Norwich to Tilbury

Document: 5.9.31 Final Statement of Common Ground - MSP
Fairwind Limited (Fairwinds Solar Farm) - Clean Version

Final Issue D

Figure 1 Interface between Fairwinds Solar Farm and the Project Order Limits

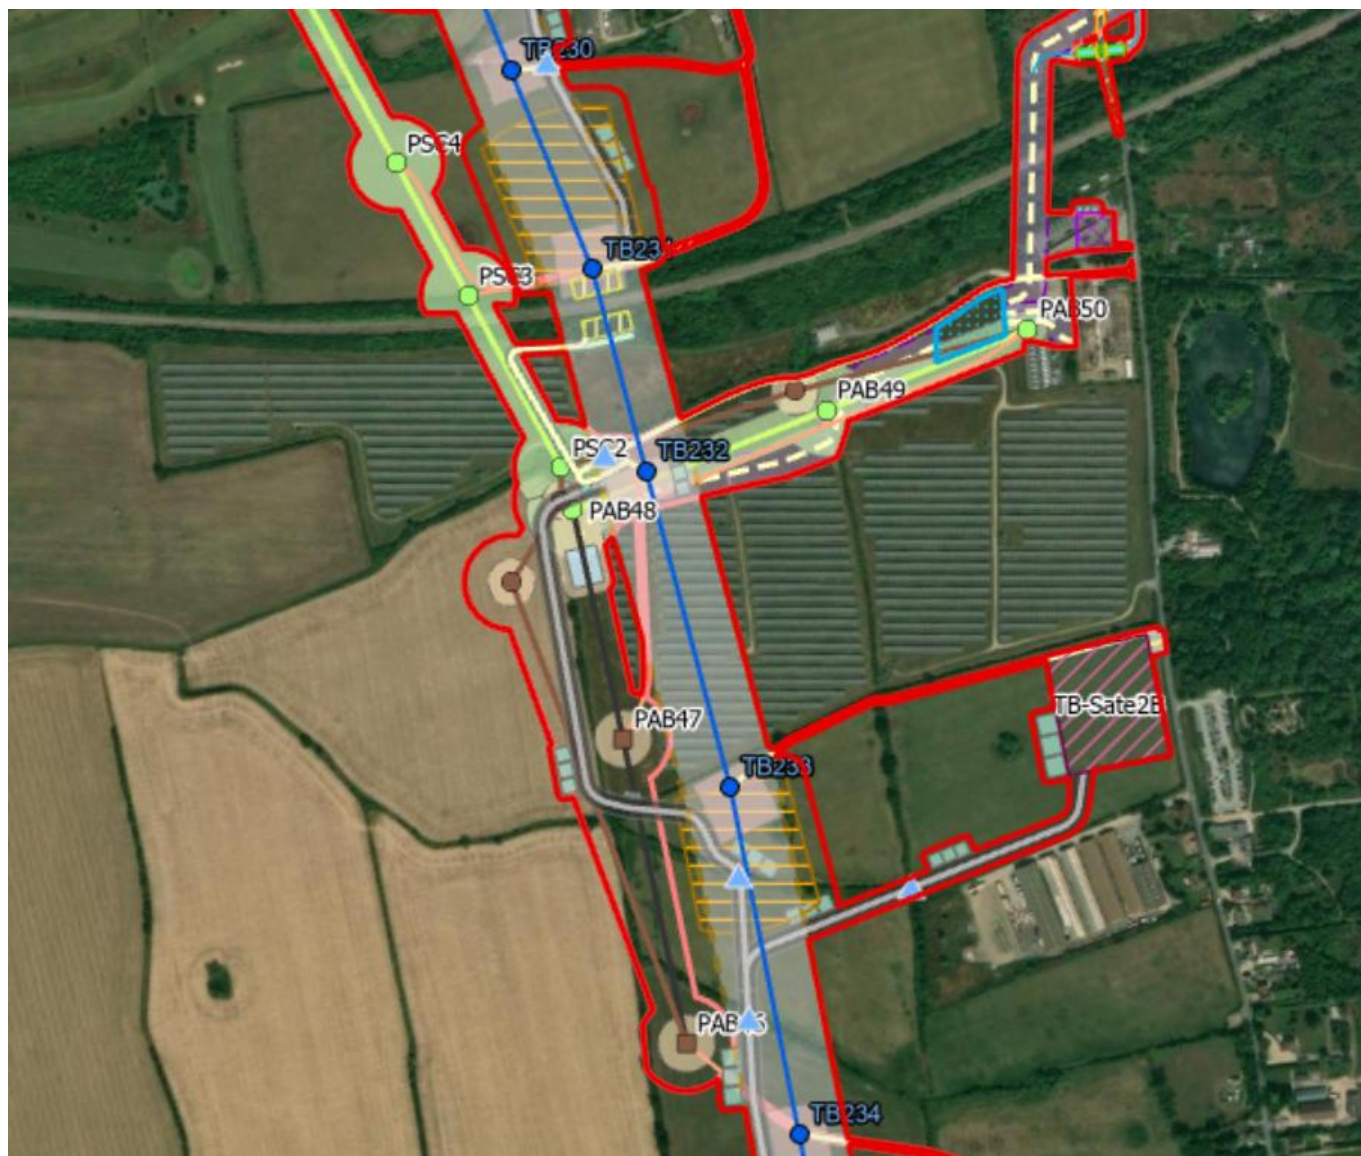
8.4	Haul Road Interface	The Applicant confirms that construction activities will be undertaken by competent contractors, with prior notice and method statements provided for works affecting the solar farm. Further details will be developed as part of the detailed design and construction planning process. The Applicant does not consider it reasonable that MSP Fairwind Limited approves the engineering design, loading calculations and specifications. Arrangement on this matter can be included any legal agreement between the parties.	MSP Fairwind Limited requires an explicit provision granting the right to review and approve the engineering design, loading calculations, and specifications of any haul roads or heavy plant crossings affecting its infrastructure. MSP Fairwind Limited considers that advance notice and provision of method statements alone is insufficient.

8.5	Compensation for loss incurred as a result of the Project – permanent panel removal and shading impacts	The Applicant notes that the anticipated working area for pylon TB232 is approximately 70m x 70m and does not anticipate that permanent removal of solar panels will be required. The Applicant acknowledges the potential for shading impacts and is continuing to explore design refinements. The Applicant notes that final pylon design parameters will not be available until 2027. Once this information is available the	MSP Fairwind Limited cannot agree the extent of impacts in the absence of final pylon design information and a detailed overlay of the Project onto the solar farm layout. MSP Fairwind Limited considers that shading is a technical (binary) impact requiring assessment through a detailed study by an independent technical advisor. MSP Fairwind Limited maintains that full technical inputs are

8.6	Construction vehicle tracking – loading risk to underground assets	The Applicant confirms that haul roads will be designed and constructed to accommodate anticipated construction traffic and loading requirements, taking into account underlying ground conditions and known infrastructure constraints. Protective measures will be implemented where reasonably required. The Applicant is open to negotiating the requirements for the haul road as part of detailed design.	MSP Fairwind Limited requires that protective measures are implemented where haul roads cross underground infrastructure, including reinforced road sections or equivalent measures. MSP Fairwind Limited also requires the right to review and approve haul road designs and associated loading assessments.

8.8	Tower impact to solar panels - earthing	The Applicant has undertaken a preliminary earthing study which did not identify impacts. A site-specific technical note is being prepared and is expected to be issued to MSP Fairwind Limited in July.. The Applicant will continue to engage with MSP Fairwind	MSP Fairwind Limited cannot agree this matter until its engineering team has received and reviewed the site-specific earthing technical note. Agreement is dependent on technical validation of the findings.
